# Technical Service Bulletin

## 43 Air suspension system fault - DTC C118D01 Compressor for level control electrical error

43 24 88 2073034/4 May 7, 2024. Supersedes Technical Service Bulletin Group 43 number 24-87 dated April 11, 2024 for reasons listed below.

Model(s)	Year	VIN Range	Vehicle-Specific Equipment
Q5, Q5 e quattro, Q5 Sportback, SQ5, and SQ5 Sportback	2023 - 2024	All	Air suspension system

**Figure 1.** Verify that the compressor electronics is part number 4M0.907.778.A.

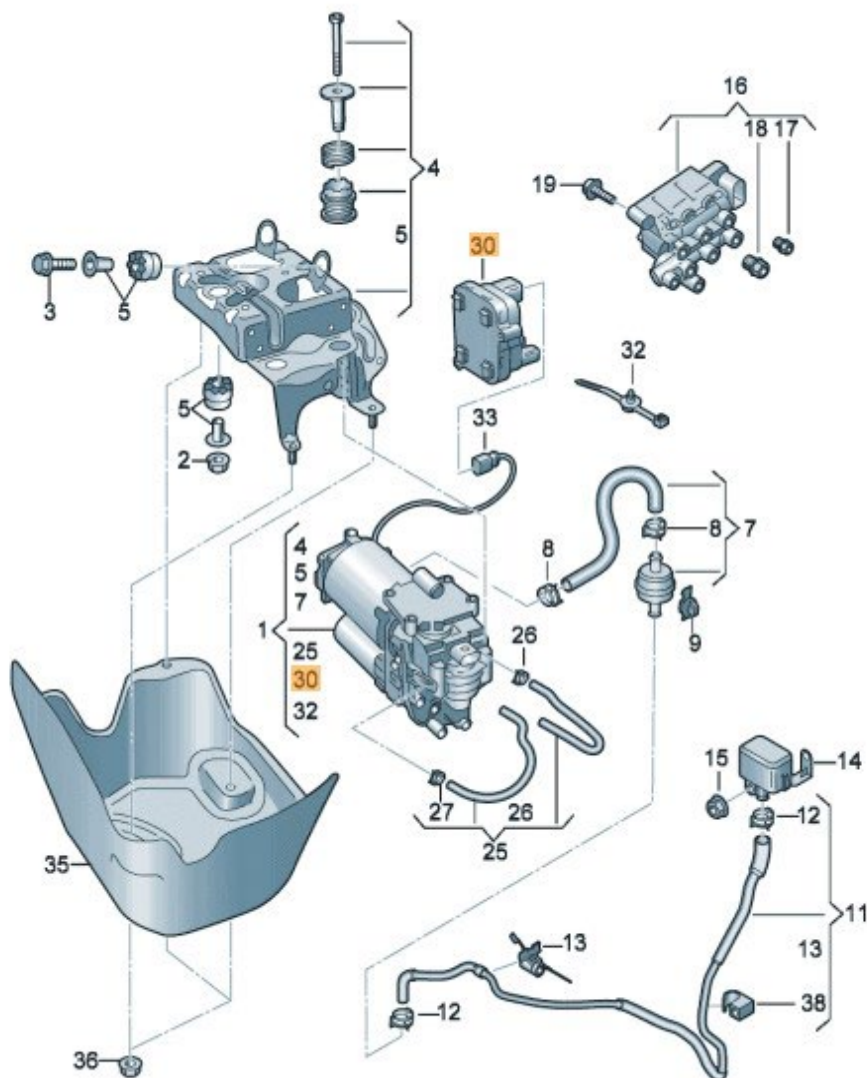
The described procedure only applies if compressor electronics with part number index A are fitted in the vehicle (affected part number 4M0.907.778.A) (Figure 1, number 30).

- If the DTC is **passive/intermittent**, delete the DTC.
- If the DTC is logged as **active/static** and remains active/static after the ignition is switched off and then on again, replace the control unit for compressor electronics J1135 (**not the air compressor**).
- Please use part number **4M0.907.778 (Without index A)**.
